MECKLENBURG COUNTY
DEPARTMENT OF ENVIRONMENTAL HEALTH

SITE EVALUATION

Re: Property located at 3109 Winding Trail, Lot 23-A

**See Diagram on Back (includes: soil areas, property lines, roads, streams, gullies, wet areas, fill areas, wells, water bodies, slopes)

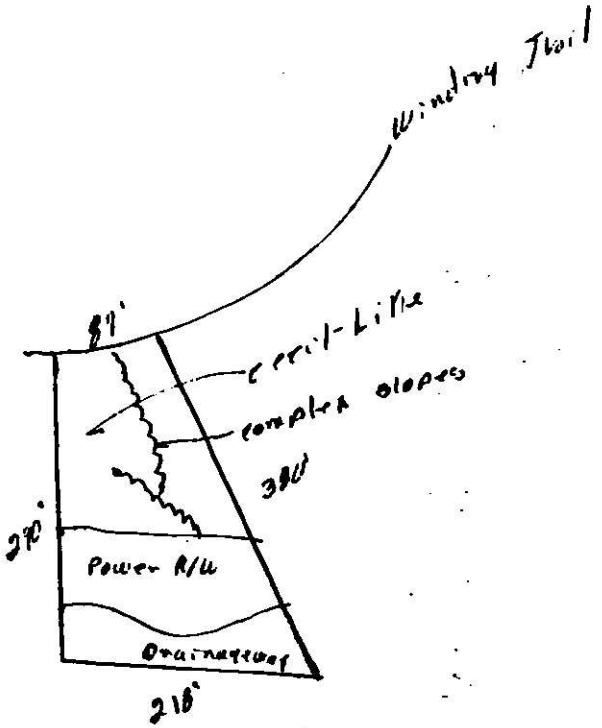
FACTORS	AREA 1	AREA 2	AREA 3	AREA 4
1. SLOPE (%)	S 8-15% / PS / U	S complex / PS / U slopes	S / PS — / U	S / PS — / U
2. SOIL TEXTURE (12-36 inches) Sandy, Loamy, Clayey (Note 2-1 Clay)	S / PS Clay / U	S / PS clay / U	S / PS — / U	S / PS — / U

3. SOIL STRUCTURE (12-36 inches)	S / PS Blocky / U	S / PS Blocky / U	S / PS — / U	S / PS — / U
4. SOIL DEPTH (inches)	S / PS 30-40" / U	S / PS <36" / U	S / PS — / U	S / PS — / U

5. RESTRICTIVE HORIZONS (Inches) (Impervious strata, Rock)	S >36" / PS / U	S / PS <36" / U	S / PS — / U	S / PS — / U
6. SOIL DRAINAGE/GROUNDWATER (external and internal)	S / PS >36" / U To Groundwater	S Eroded / PS Areas / U Channel road	S / PS — / U	S / PS Drainage way / U

7. OTHER (Specify)	S Somewhat / PS Limited / U Area	S / PS / U	S Power / PS line / U R/W	S / PS / U
8. SOIL GROUP	16 A	16 A	—	—
9. SITE CLASSIFICATION	Provisionally Suitable	unsuitable	unsuitable	unsuitable

10. SOIL SERIES	Cecil Lake	complex slopes	Powerline R/W	Drainageway

Winding Trail
87'
cecil-Little
complex slopes
380'
270'
Power R/W
Drainageway
218'

PLOT OF SYSTEM

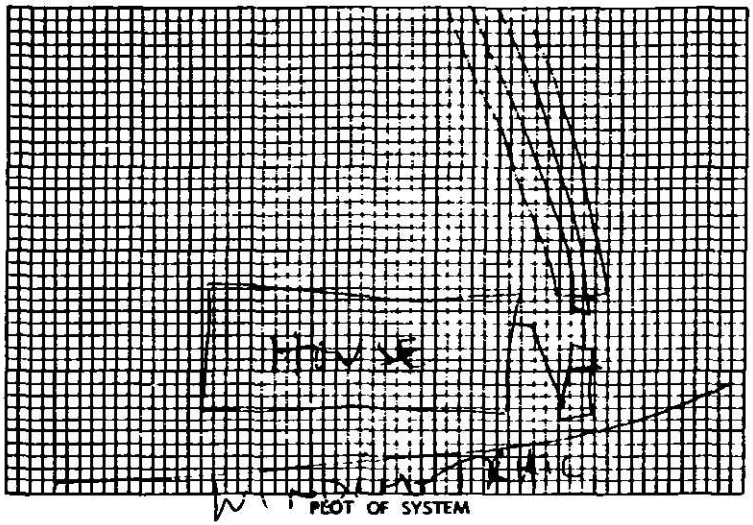
4 line x 3' wide x 12' stone w/ sod board w/ stone cover w step down as needed

Permeability Rate PS

Liquid Capacity of Tank 1500

Tank Construction PRECAST

Total Line Length 300'

Number of Lines 4 x 75

Distance from House 5+

Distance from Property Line 10+

Distance from Well 50+
